STAFF REPORT: AUGUST 14, 2024 MEETING – *Revised 8/14/24*

APPLICATION NUMBER: HDC2024-00421

ADDRESS: 2244 WABASH

SCOPE: DEMOLISH REAR OF HOUSE* (WORK COMPLETED WITHOUT APPROVAL);
ERECT REAR ADDITION

Applicant elevation view of south wall.

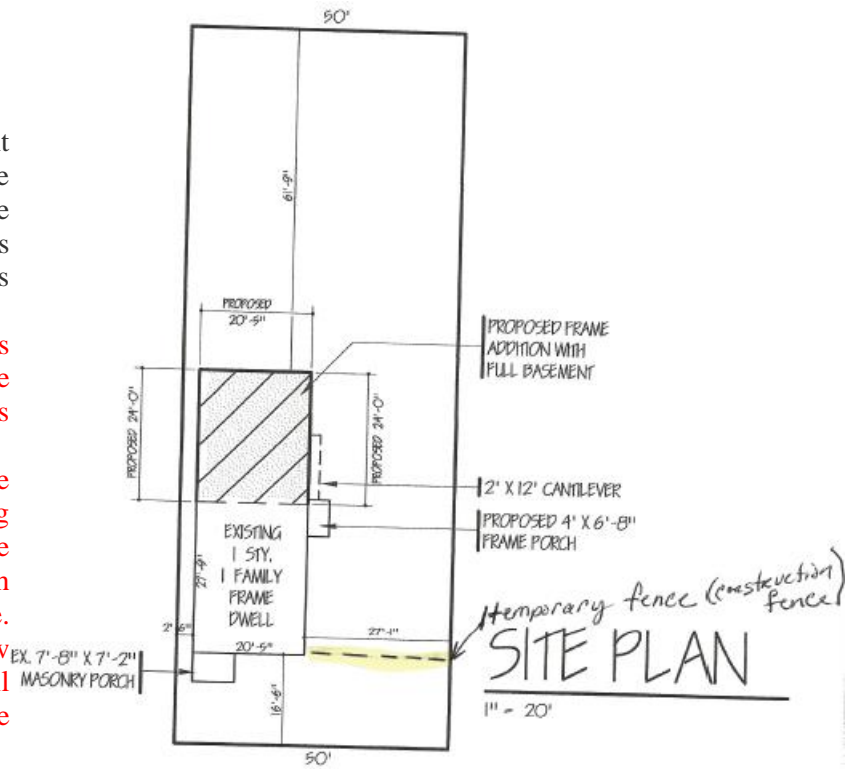
- The historic side wing extended from the house further than what is proposed for the rebuild. Based on the below photos and the elevation drawing.

The above photos, copied from earlier in the staff report, show the side wing extended further than what is proposed, when compared with the elevation drawing and floor plan. The wing is indicated to extend 2' from the house's south wall.

It is staff's opinion the side wing should extend at least to the depth of the side porch, which is noted as four feet wide (area in red box) and closely in line with the historic footprint .

- The roof of the new construction addition will be slightly lower than the historic house's roof.
 - **The south wall of the side wing will extend 4' (not 2') from the main house.**

Undated applicant photo

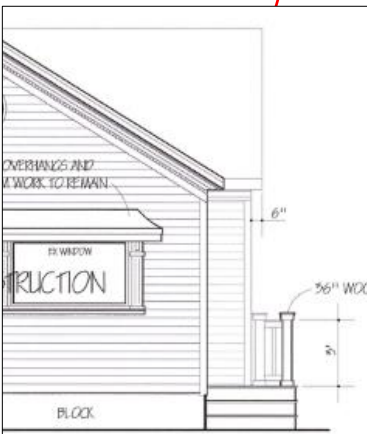
- The undated applicant photo and a 2005 aerial photo of the rear of 2244 Wabash, before the shed addition was demolished (sometime between 2006 and 2009), shows how the side wing cross gable roof and the rear of the front gable roof came together. The rear gable wall should be replicated on the existing structure. This would allow the lower height roof of the new addition to easily and clearly meet the gable wall of the historic dwelling, as indicated by the red lines on both photos.
